ADDENDUM NO. 3

Reference: Student Activity Center Addition to the Stromberg Athletic Complex
Weber State University – Ogden, Utah
DFCM Project No. 12031810

Addendum 003

project:	WSU Stromberg Student Activity Center	**project no:**	12475
date:	2012-10-18	**no. pages:**	77
owner:	DFCM		
contractor:			
bid date:	2012-11-01	**bid time:**	12:00 pm

D5 DOOR TYPES LEGEND

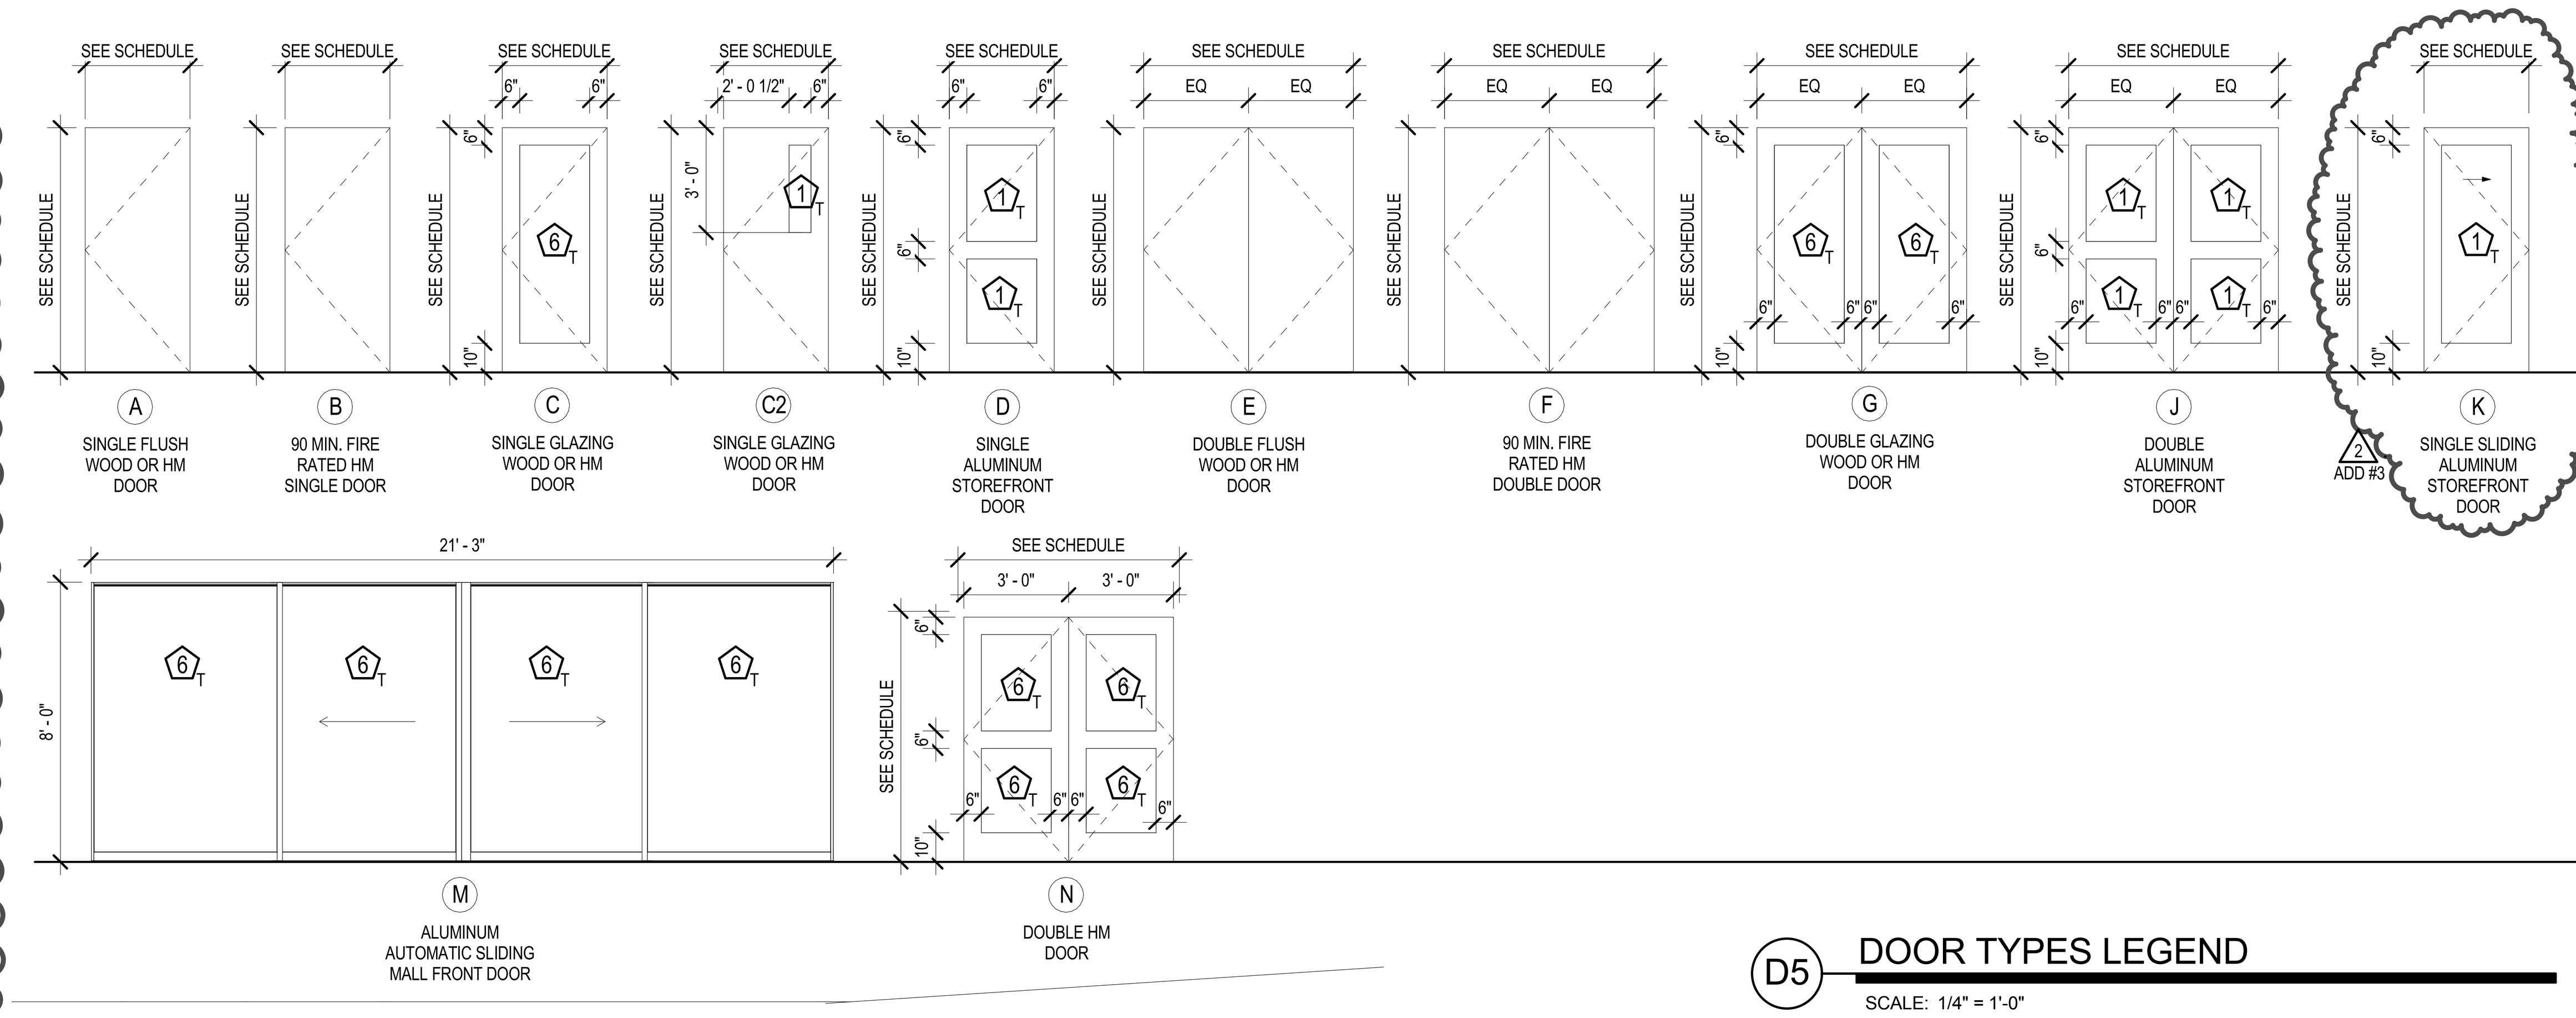
3.13	QUESTION: Door 100 currently calls for a 21'-3" [255"] x 8'-0" [96"] auto bi-part sliding door. The largest that we can go to is 18'-9" [225"] and doubt that any door manufacturer can go to 255". Can the overall package width be reduced to 225" (instead of 255")? OR Two (2) 10'-7 ½" bi-part sliders instead of one (1) over sized door? RESPONSE: Door 100 has been updated to be a single sliding door. The whole unit measures 126" wide X 96" tall. The actual door panel is 63" wide X 96" tall. See revised door schedule A600.

3.14	A600	See attached for revised sheet for revisions to the Door Schedule, updated Door Type K, and elevation A5, Type 1 Curtain Wall Frame add detail call out: E5/A561.

VERTICAL SPACE ALLOCATION - TYPICAL OFFICE SPACE

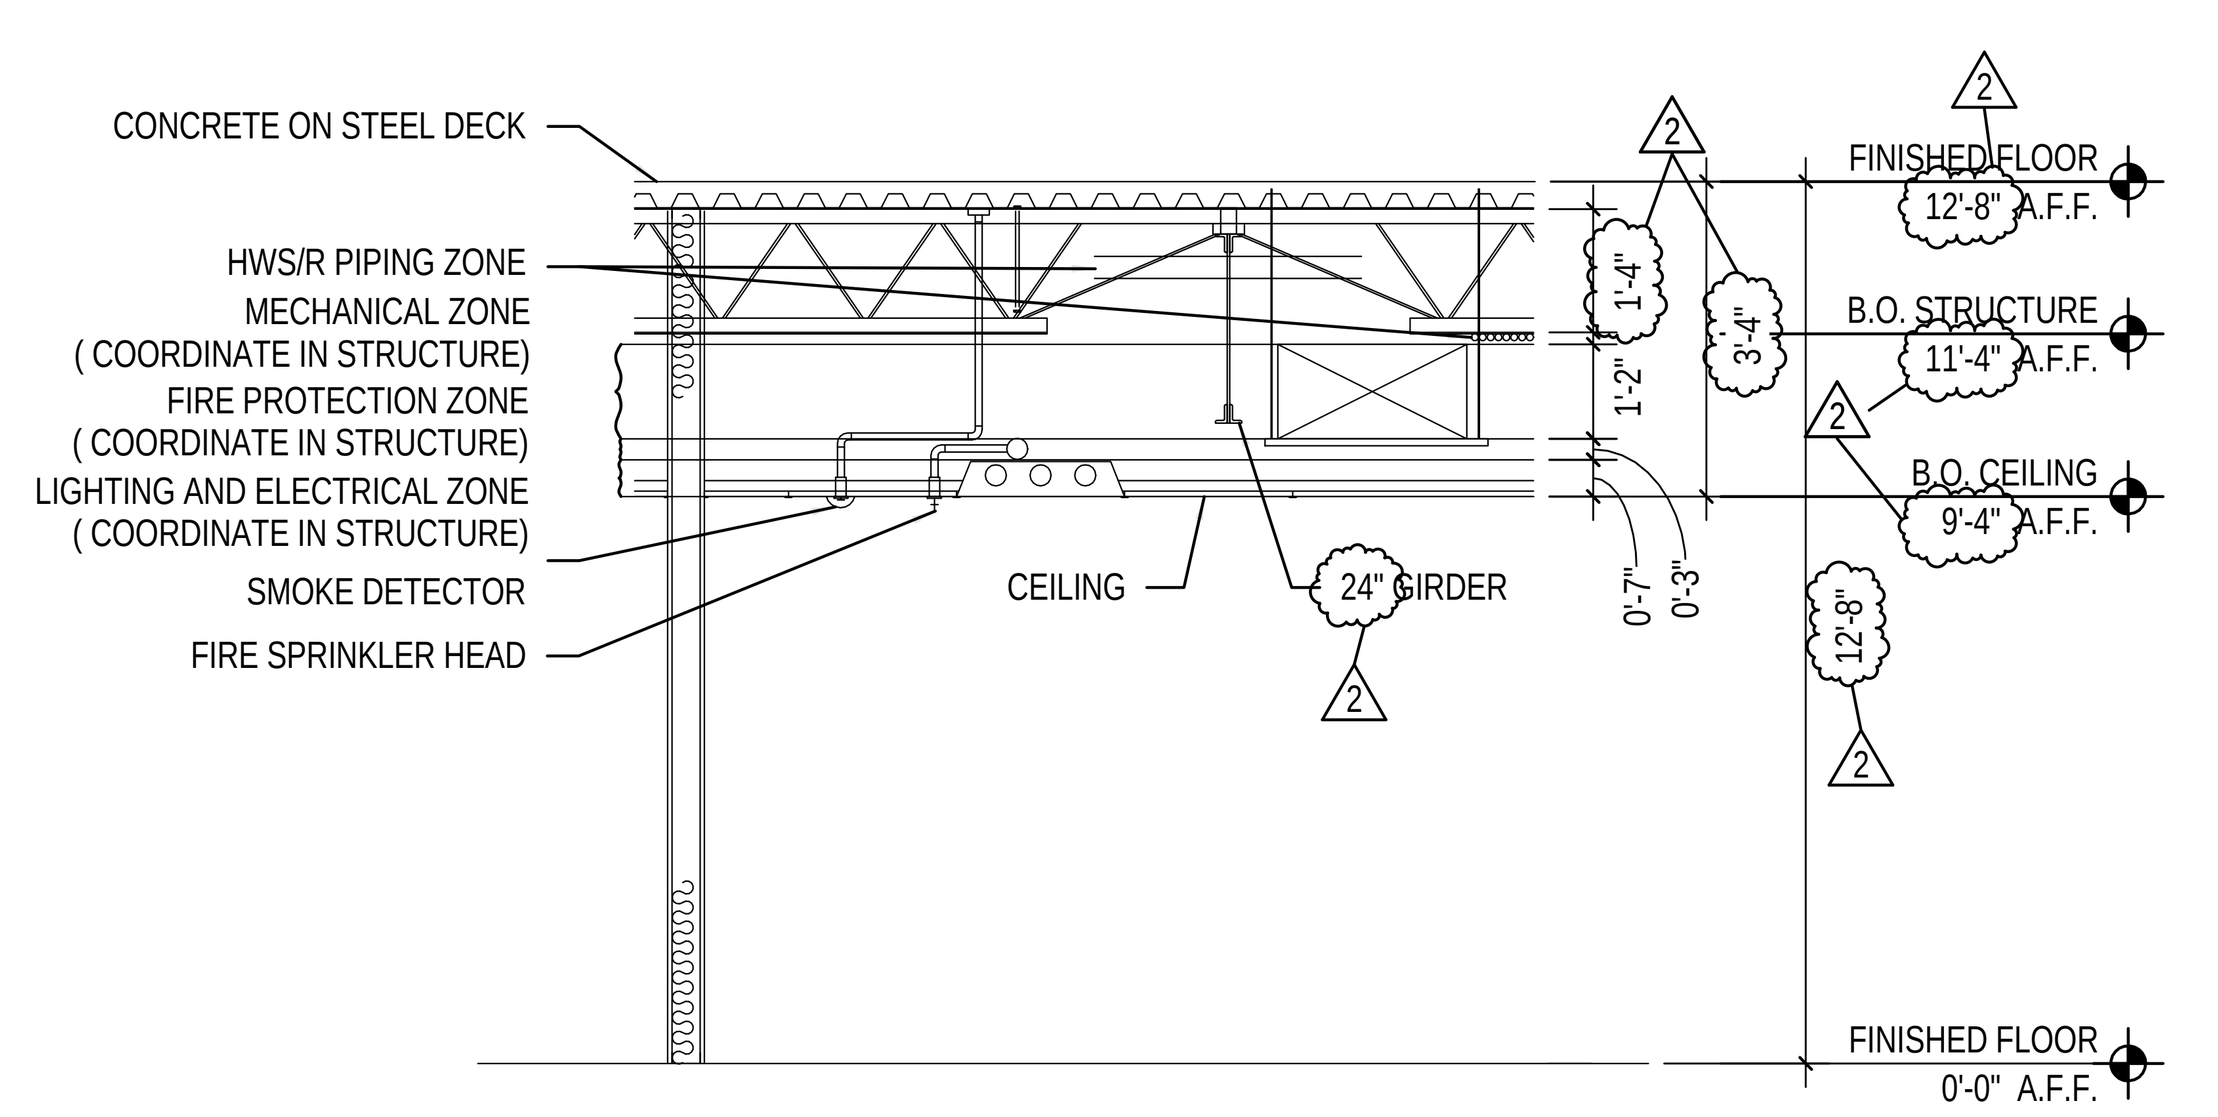
Item No.	Add, Delete or Clarify	Specification Section or Drawing No.	Reference / Description:
1.	Clarify	M001	• Updated the Vertical Space Allocation Detail.
2.	Add	M113.1	• Add two (2) Return Air Grilles in the ceiling at Lobby – 102.
3.	Clarify	M125.1	• Provided a tag for the water meter shown. • "WM-2" on Detail #3.
4.	Delete / Clarify	M143.1	• Delete previously shown CU-1 on North end of Roof near gridlines B and 4. • Renumber CU-2 and CU-3 near gridlines EB and 4 to CU-1 and CU-2 respectively.
5.	Clarify	M202	• Provided a tag for the water meter shown. "WM-3".
6.	Clarify	P113.1	• Provided a tag for the water meter shown. "WM-1".
7.	Clarify / Delete	P601	• Deleted water meter #2 for HWR system. • Updated water meter numbering.

NEW PARTIAL POWER SINGLE LINE DIAGRAM

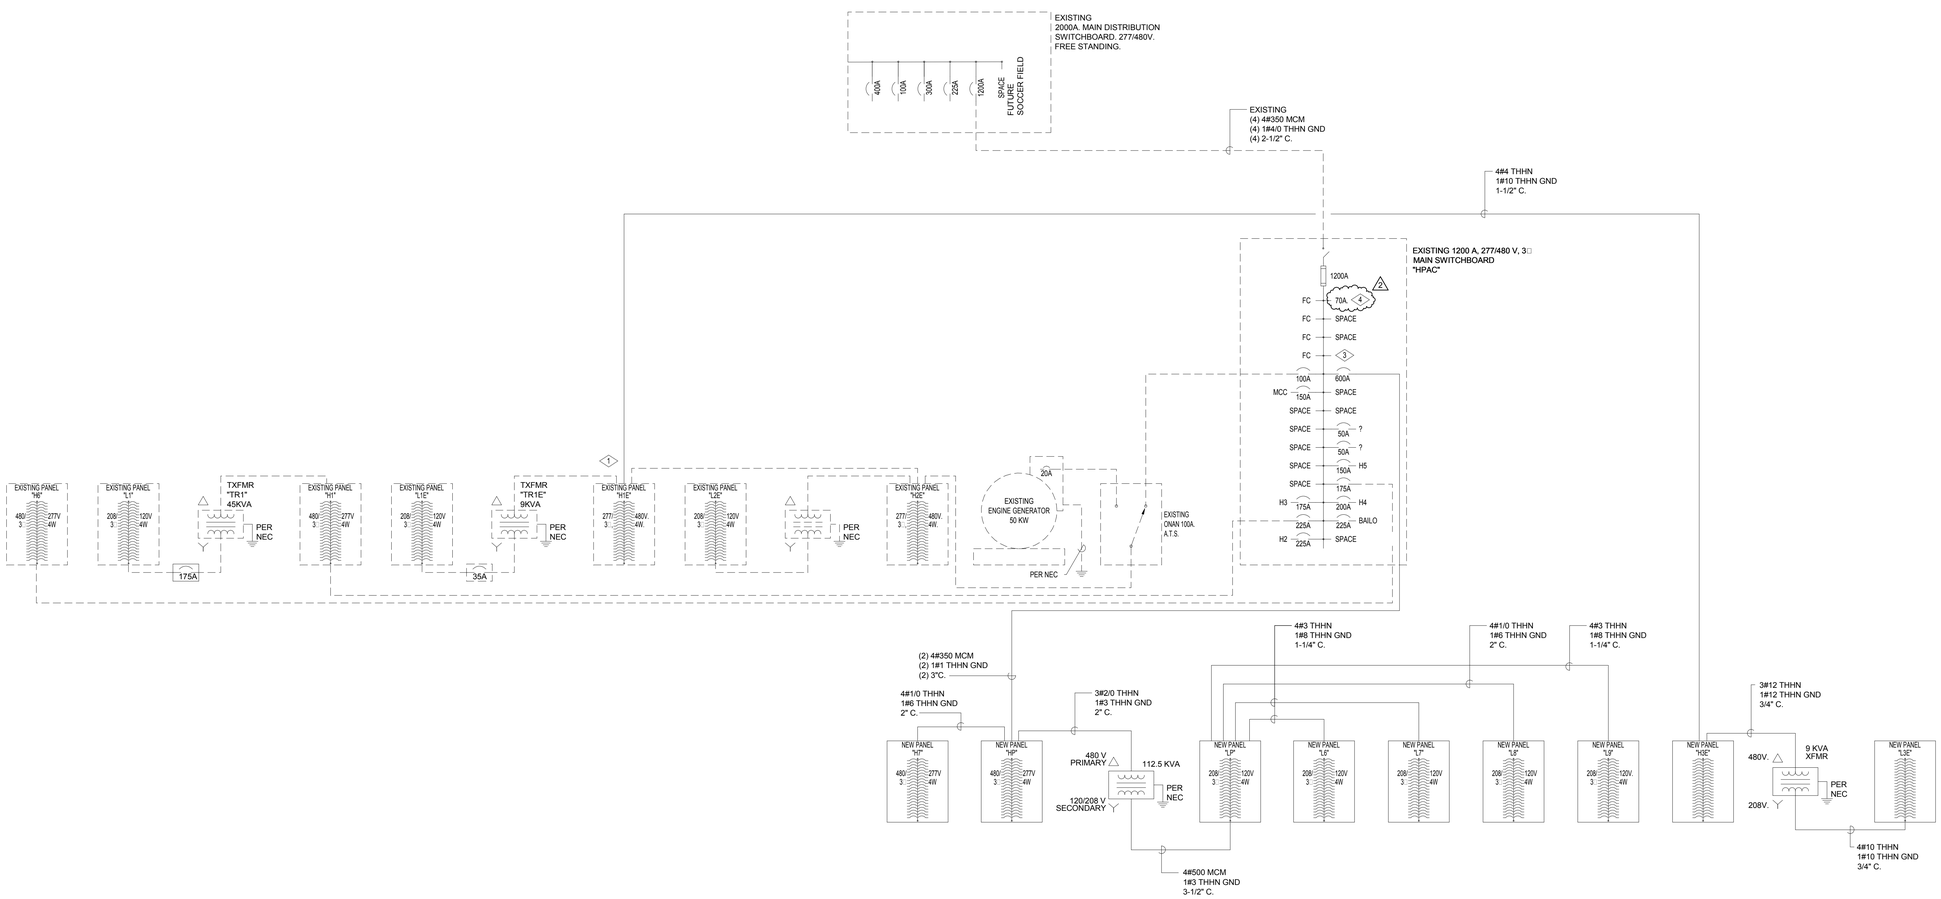
1. Add a 70A. 3-pole circuit breaker in existing main switchboard "HPAC" for new pump. New circuit breaker to have the same AIC rating as existing.

FIRE ALARM RISER DIAGRAM

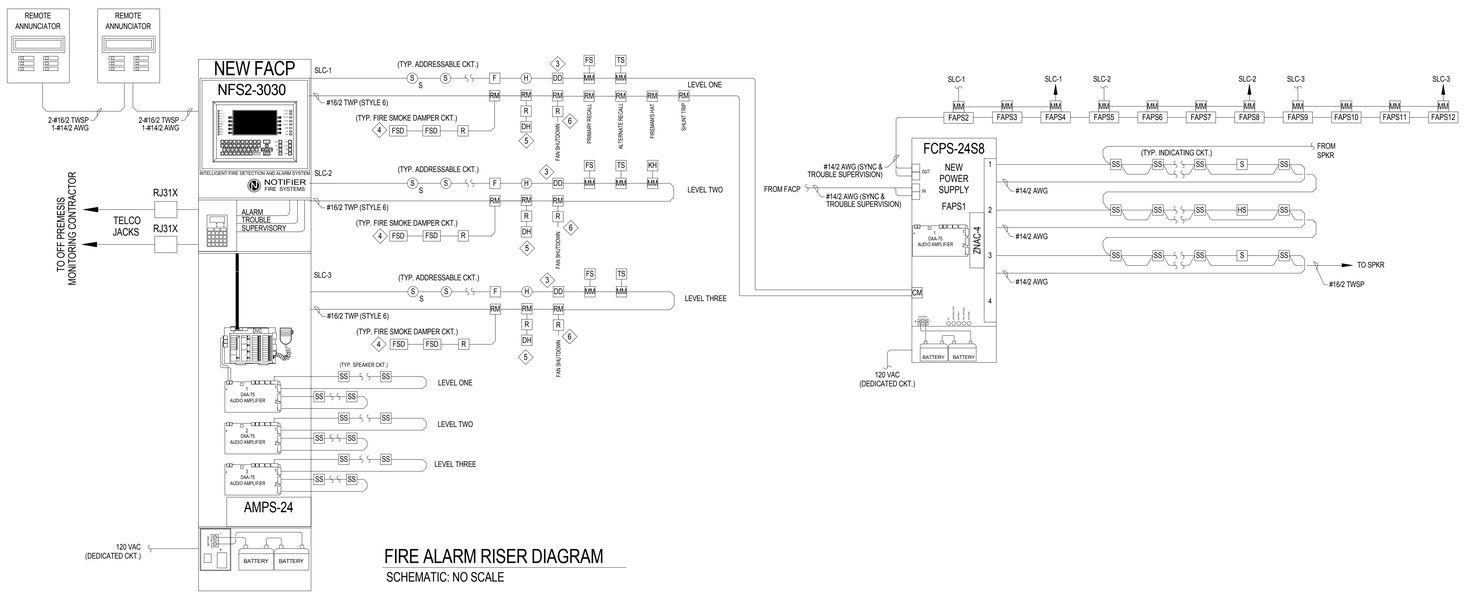
1. Mechanical schedule,
   a. Delete air cooled condensing unit split system ACC-3, CU-3, and electric unit heater "UH-1" from mechanical schedule.
   b. Change conductor sizes for CU-2 from #10 conductors to #12.
   c. Add water meter WM-1,2.
2. Panel L10 has been added.

1 DEMOLITION SITE PLAN - ELECTRICAL
1/16" = 1'-0"

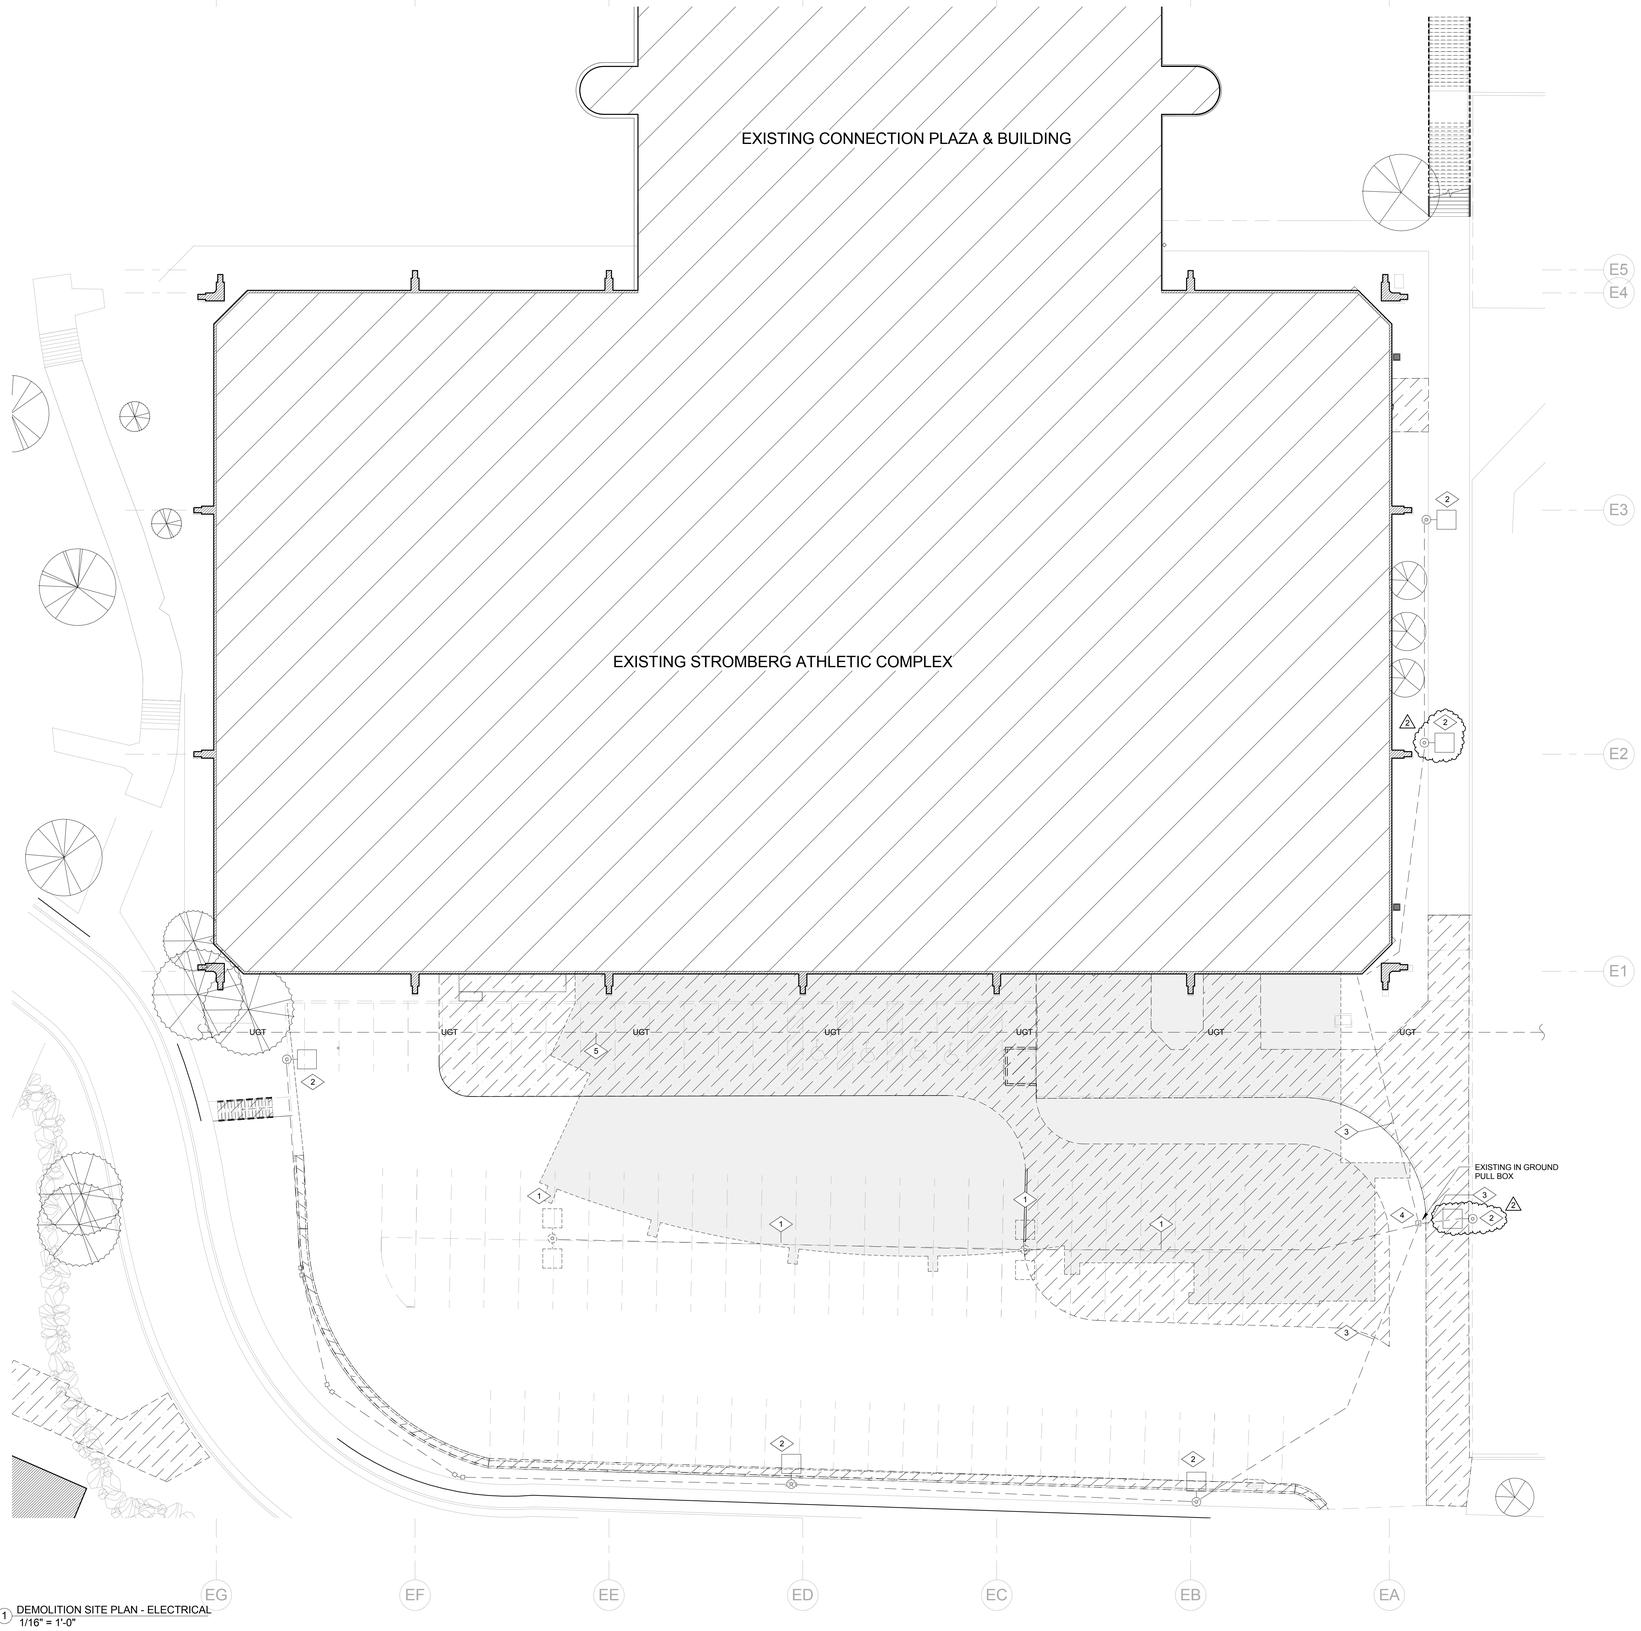
1. Refer to reference note #2 for revisions.
2. Add the following special note:
   "Contractor is to provide temporary power to the existing pole mounted light fixtures during the construction. At the end of the project, tie the circuit in new panel through the new time clock."
3. Note #5 has been modified. See revised drawings for more information.
